ADDENDUM NO. 2

City of Lakewood Angle Lane/Elwood Drive Pedestrian Improvements City Project No. 302.0156

Date of Issue: April 21, 2023

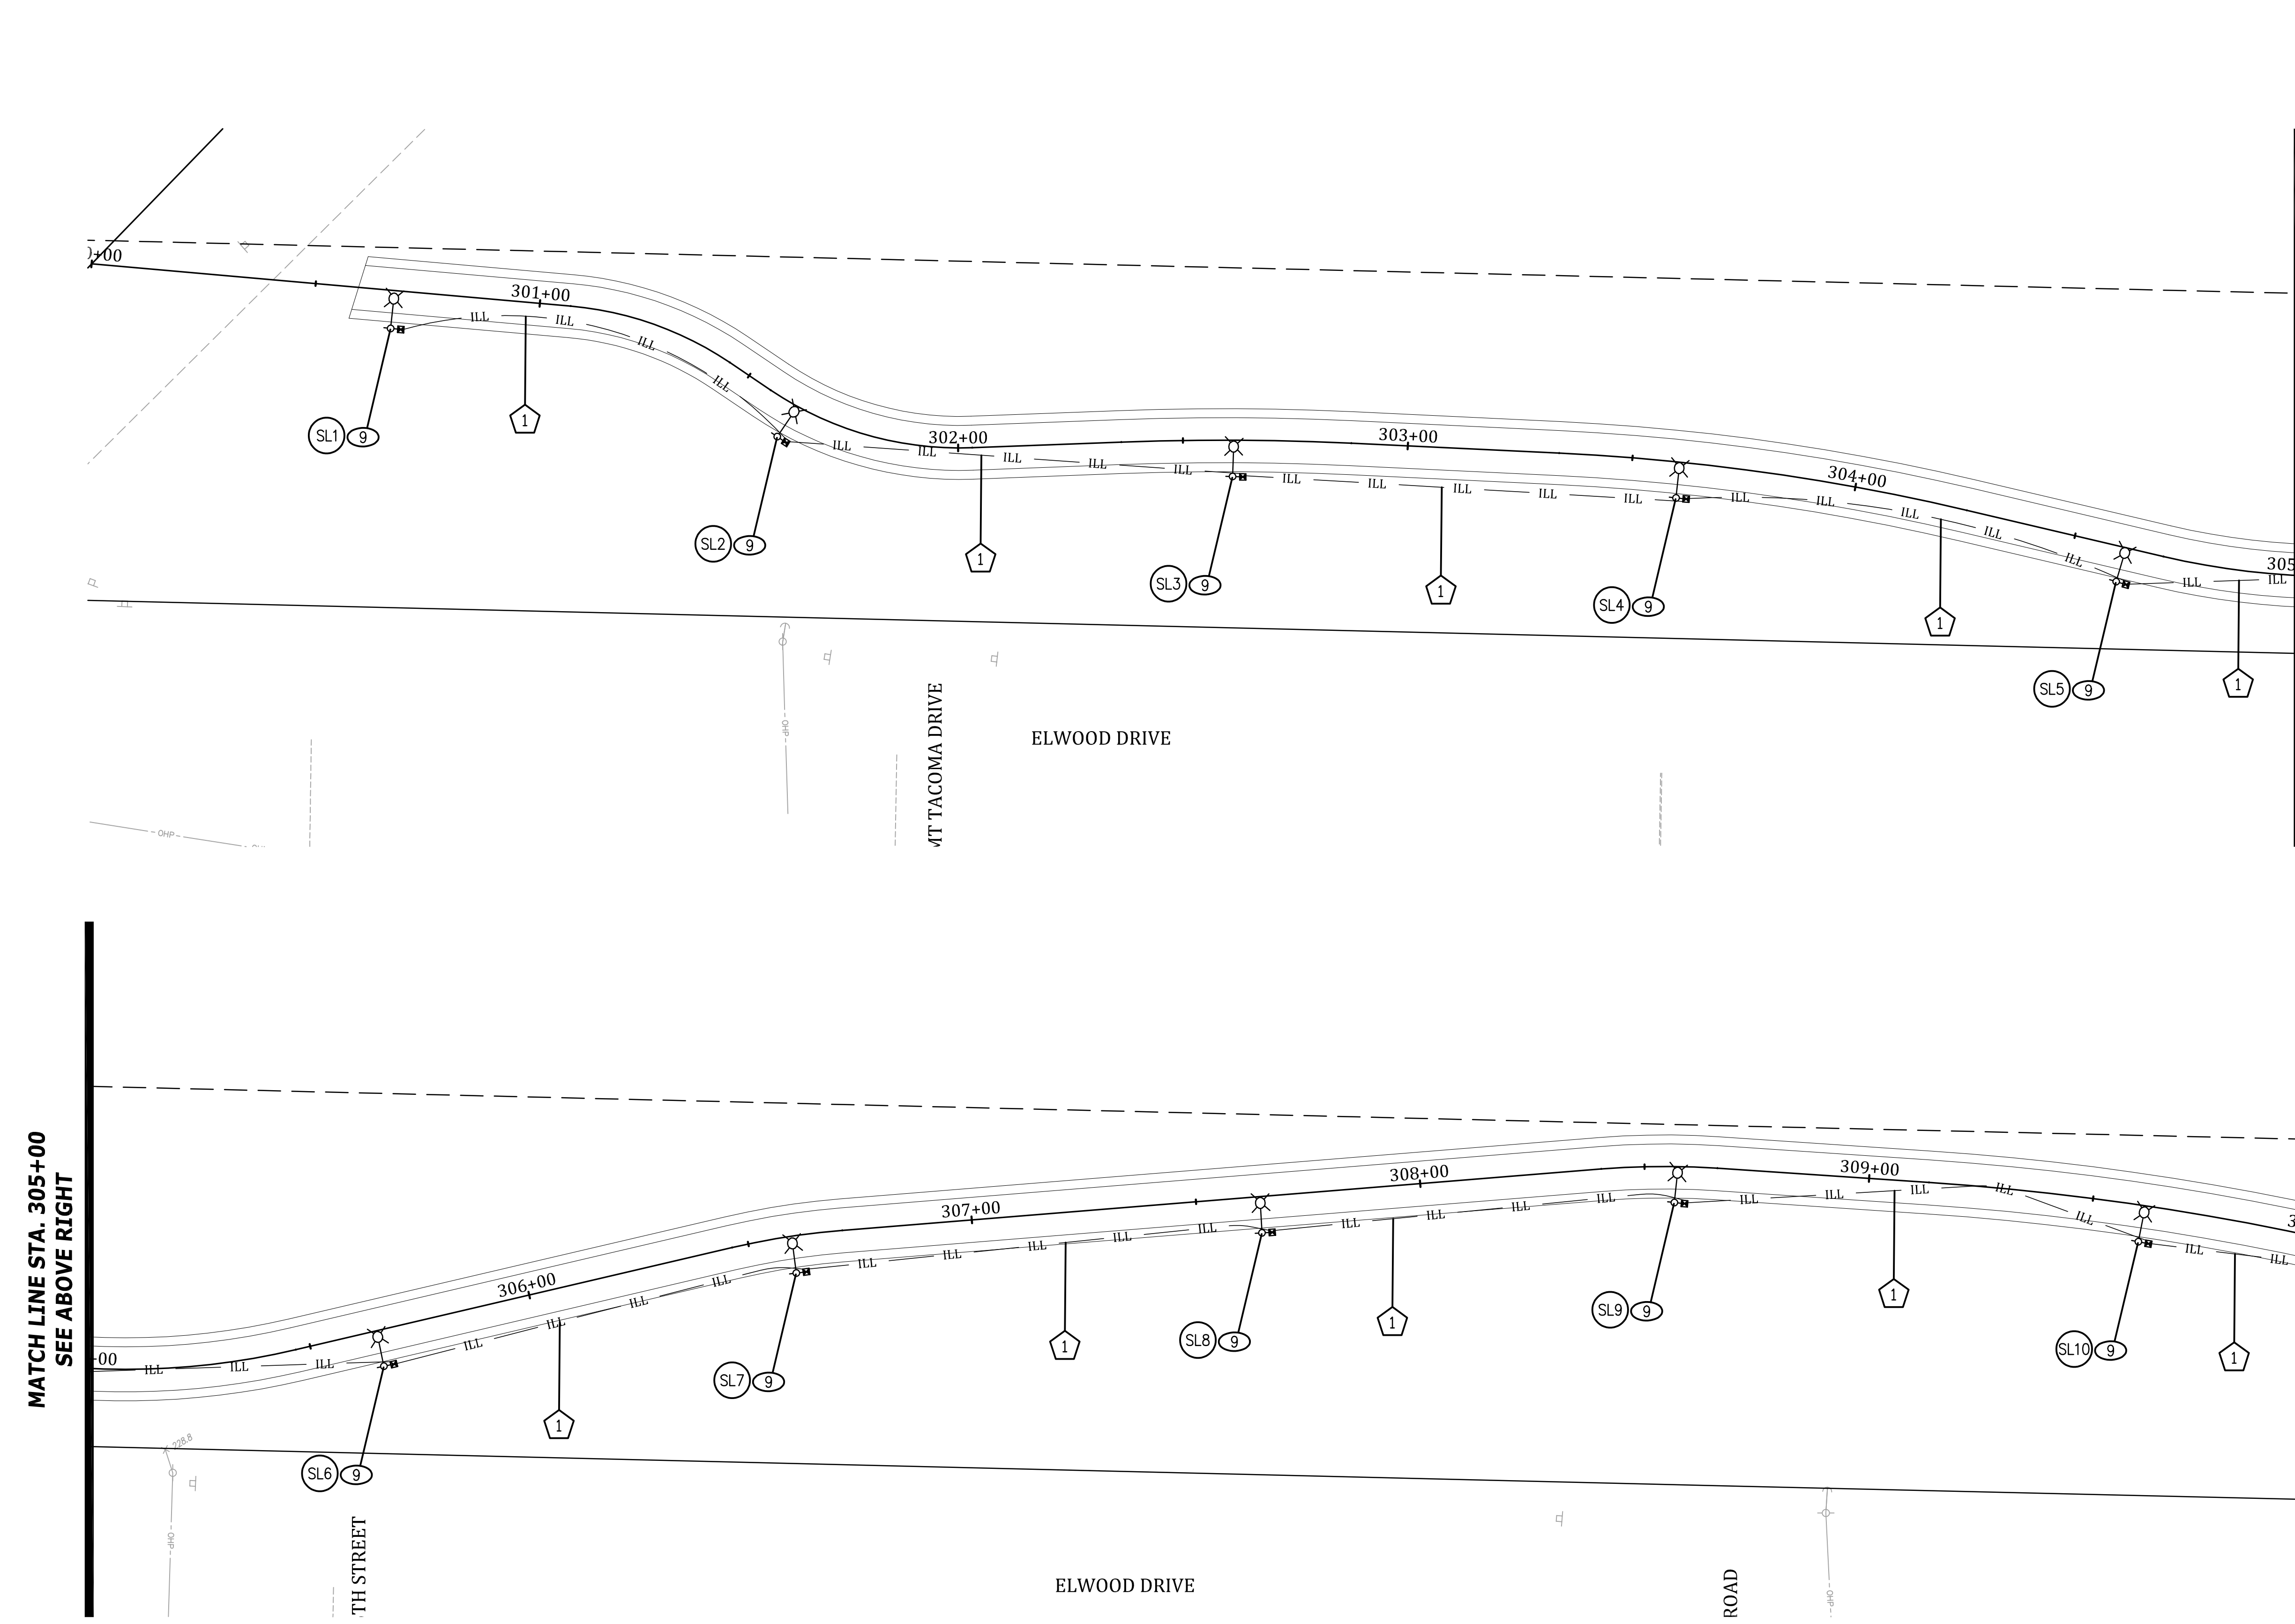
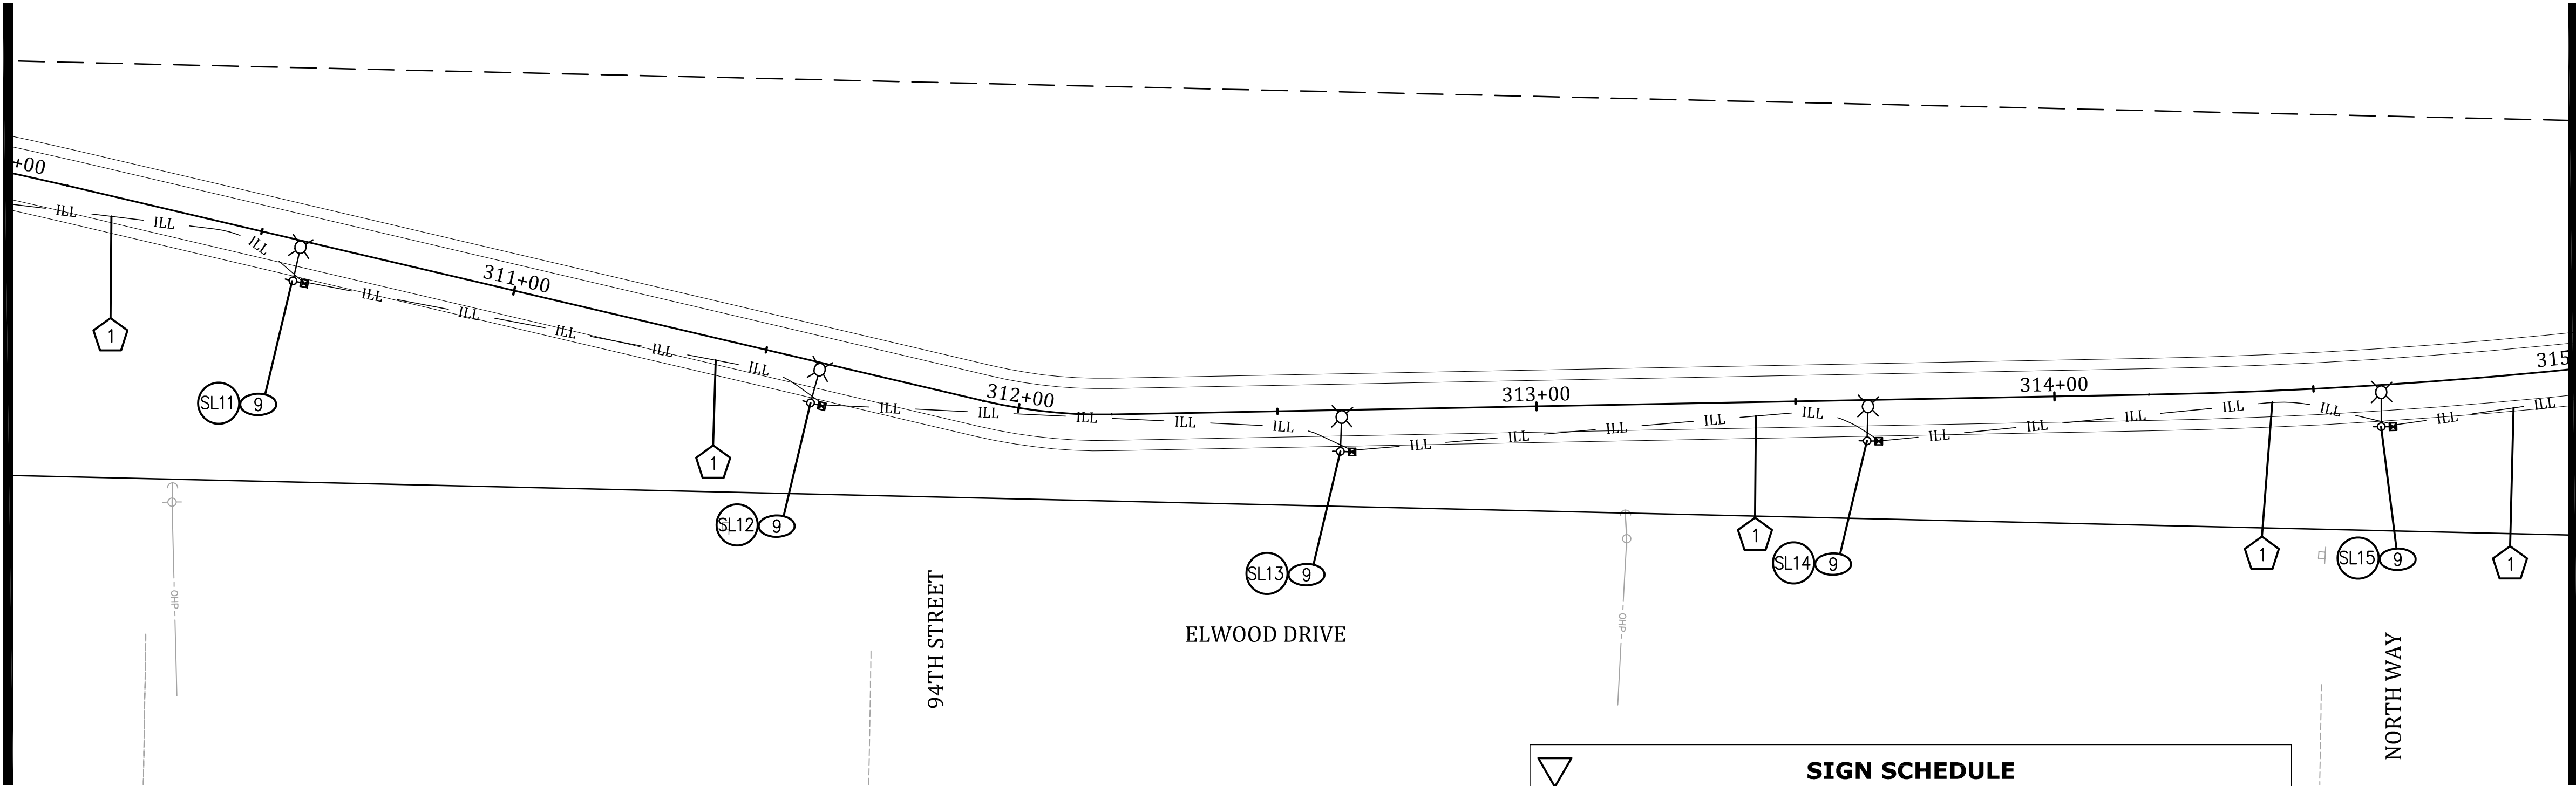
1. **Sheet 41-44 (IC3-IC6) – Remove and Replace Sheets.** Two luminaires on IC3 were noted as SL1; one at 300+60 and one at 301+60. This modification provided the information in the table for SL1 at Sta 300+60 and renumbered street lights north of that. There are 37 street lights on the project, not 36 as previously numbered.

No.	Release/Revision	Re. Date	Re. By	Designed By:			Project Name:	Job No.
1	ADD INFORMATION FOR LIGHT POLE AT STA 300+60. RENUMBER LIGHT POLES	4/21/23	TSP	Drawn By:			ANGLE LANE / ELWOOD DRIVE PEDESTRIAN IMPROVEMENTS	302.0156
				Checked By:				Drawing No.
				Approved By:				IC3
				Project Start Date: 12/06/22 Drawing Scale: AS SHOWN Electronic File Name: 302.0083			ILLUM./CHANNELIZATION PLAN - STA. 300+00 TO STA. 300+10	Sheet 41 of 49

SL#	ALIGN	STATION	OFFSET	HEIGHT	MAST ARM	HEAD WATTAGE
1	ELWOOD	300+60	9' RT	15'	4'	68
2	ELWOOD	301+60	9' RT	15'	4'	68
3	ELWOOD	302+60	9' RT	15'	4'	68
4	ELWOOD	303+60	9' RT	15'	4'	68
5	ELWOOD	304+60	9' RT	15'	4'	68
6	ELWOOD	305+60	9' RT	15'	4'	68
7	ELWOOD	306+60	9' RT	15'	4'	68
8	ELWOOD	307+60	9' RT	15'	4'	68
9	ELWOOD	308+60	9' RT	15'	4'	68
10	ELWOOD	309+60	9' RT	15'	4'	68

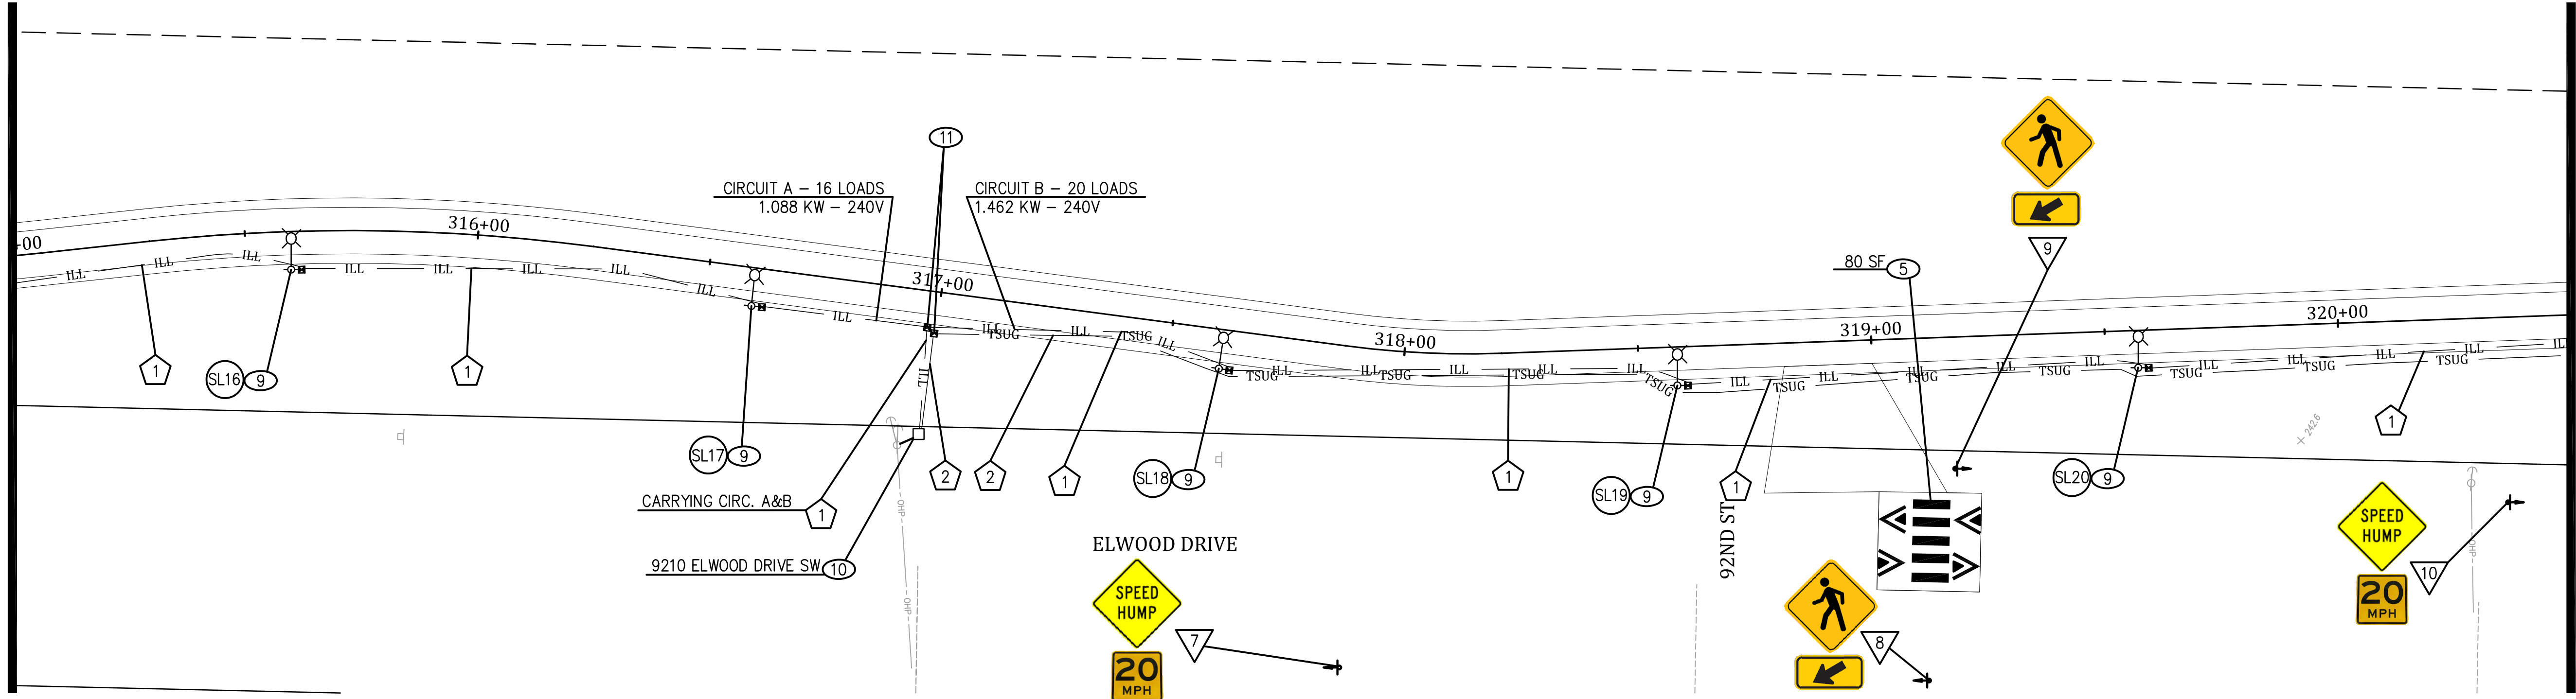
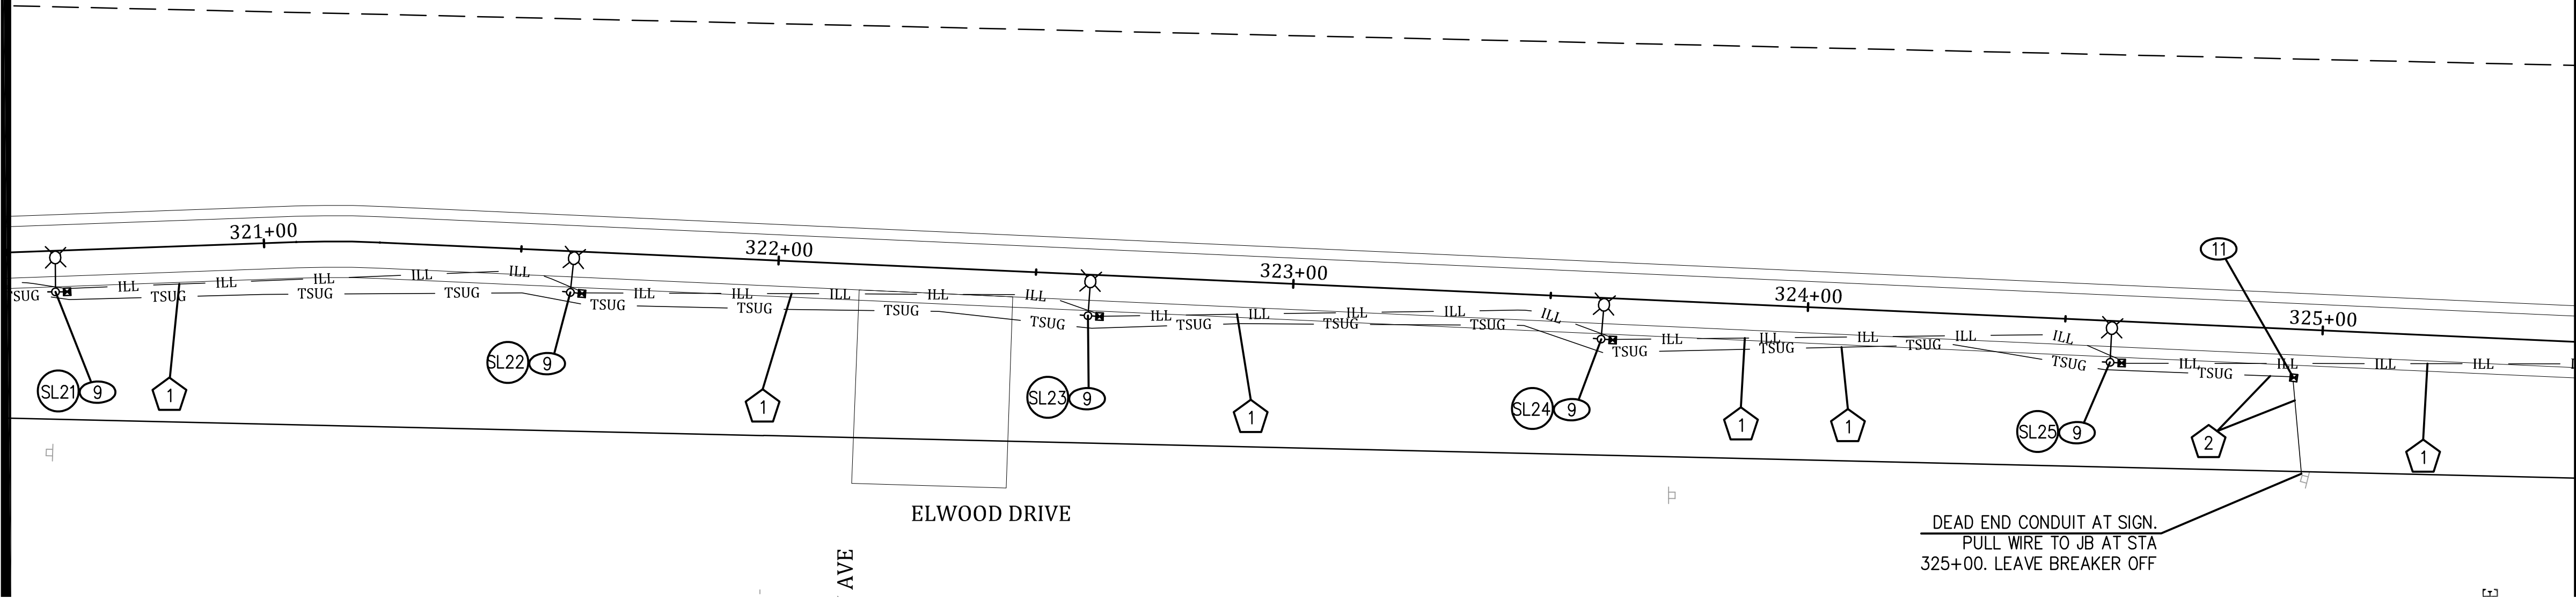
No.	Release/Revision	Re. Date	Re. By	Designed By:	Project Name:	Job No.
1	RENUMBER LIGHT POLES	4/21/23	TSP	T. POKSWINSKI	ANGLE LANE / ELWOOD DRIVE PEDESTRIAN IMPROVEMENTS	302.0156
				Drawn By:		Drawing No.
				T. POKSWINSKI		IC4
				Checked By:		Sheet
				C. T. HILL		42 of
				Approved By:		49
				P. BUCICH		
				Project Start Date: 12/06/22	ILLUM./CHANNELIZATION PLAN - STA. 310+00 TO STA. 320+50	
				Drawing Scale: AS SHOWN		
				Electronic File Name: 302.0083

LUMINAIRE SCHEDULE						
SL#	ALIGN	STATION	OFFSET	HEIGHT	MAST ARM	HEAD WATTAGE
11	ELWOOD	310+60	9' RT	15'	4'	68
12	ELWOOD	311+60	9' RT	15'	4'	68
13	ELWOOD	312+60	9' RT	15'	4'	68
14	ELWOOD	313+60	9' RT	15'	4'	68
15	ELWOOD	314+60	9' RT	15'	4'	68
16	ELWOOD	315+60	9' RT	15'	4'	68
17	ELWOOD	316+60	9' RT	15'	4'	68
18	ELWOOD	317+60	9' RT	15'	4'	68
19	ELWOOD	318+60	9' RT	15'	4'	68
20	ELWOOD	319+60	9' RT	15'	4'	68
ALL POLE FOUNDATIONS SHALL BE 2' IN DIAMETER. 15' POLE FOUNDATION DEPTH SHALL BE 3'.
